From: Ted Walters [ted.walters@blueyonder.co.uk]
Sent: 19 December 2012 12:19
To: 'walters ted'
Subject: FW: Pre application advise for 40 New End Square (ref CA\2011\ENQ\05200)

PRE - APPLICATION ADVICE - SEPT 2011

SITE VISIT**NOV 2012**

RE Application Ref 2011/5217/L

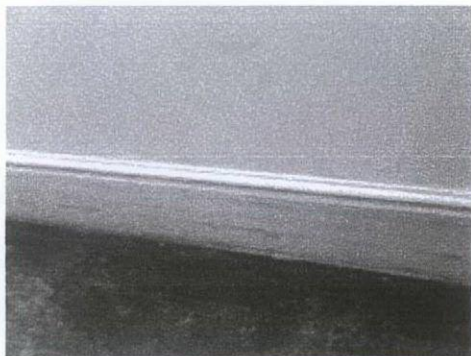
e) The t and g flooring and Taurus skirting boards throughout the ground floor were installed in the 1970s and are of no historic value (see photos)

The pine floor boarding to the 1st floor is of historic value so the new floor will be fitted onto packing timbers approx 20 - 80 mm above (see photos)

New item) The breeze block wall at the head of the basement staircase installed in the 1970s is of no historic value and can be removed to BC approval (see photo)
